ATTACHMENT I

Marked-up Technical Specification Page:

5-4

SAFETY EVALUATION

FIGURE 1

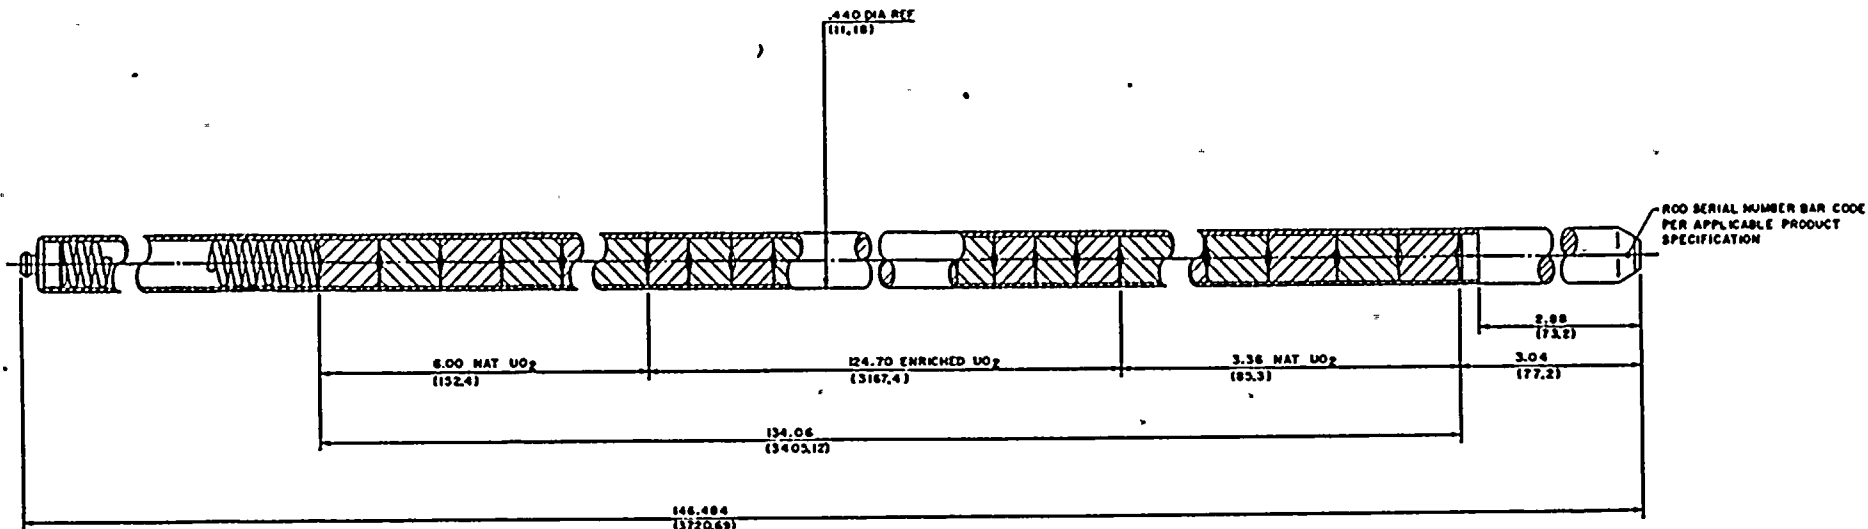
The nominal active fuel length of reload fuel will be reduced from 136.7 to 134.1 inches by removing approximately 2.64 inches of natural uranium from the lower axial blanket. This removal of material reduces the lower axial blanket length from 6.0 inches to 3.36 inches (Figure 1). In cycle 8 the shortening of the axial blanket in the reload fuel will result in a total reduction in the core's active fuel length of approximately 3250. feet, or 0.75%. The impact of this design change on the core power peaking and on the mechanical compatibility of reload fuel has been carefully evaluated by FPL. Results indicate that the proposed design change will have a negligible effect on the safe operation of the plant. These results are discussed below.

The proposed new dimensions of the lower end cap and zircaloy cladding were selected using two criteria. The first criteria was to minimize the length of axial blanket material removed from the pellet column. The second criteria was to position the cladding end cap weld above the contact point of the lower grid spring (given that the inter-grid spacing not be changed).

The dimensions selected ensure that the lower grid spring will contact the solid end cap, whereas previously the lower grid spring contacted the cladding. This positioning of the contact point on the solid end cap should also help eliminate lower grid spring fretting as a potential failure mechanism.
